V2500-A1/A5/D5 PROPULSION SYSTEMS SERVICE BULLETIN

This document transmits the Initial Issue of Service Bulletin EV2500-72-0432

ENGINE – PROVIDE IDENTIFICATION FOR NEAR NET SHAPE CASTINGS FOR HPT DUCT SEGMENTS

Location of HPT Duct Segments
Figure 1

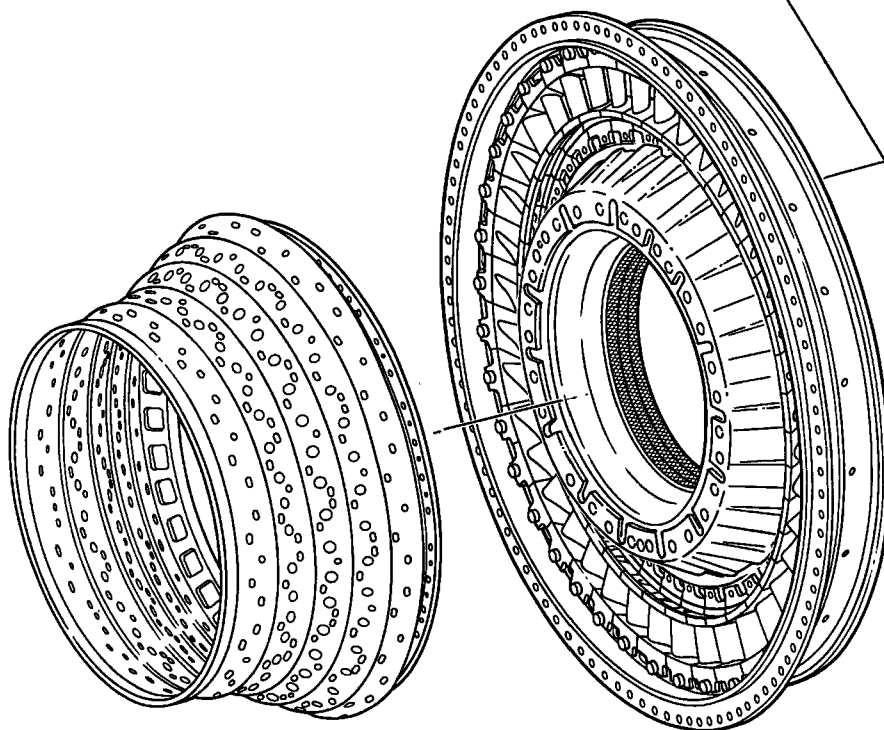
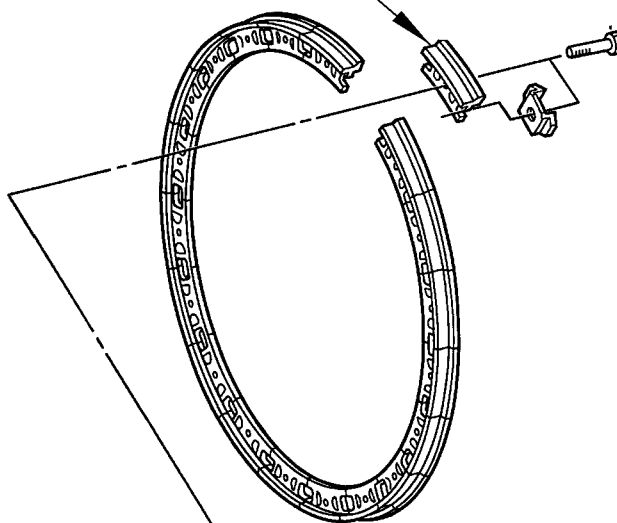
- (1) Install the new First Stage Duct Segments (20 off) PN 2A3569 for A1 or PN 2A3568 for A5/D5 in accordance with the current maintenance and overhaul procedure found in the Engine Manual 72-44-00. See Figure 1.
- (2) Recording Instructions
 - (a) A record of accomplishment is required.

REPLACE DUCT SEGMENT
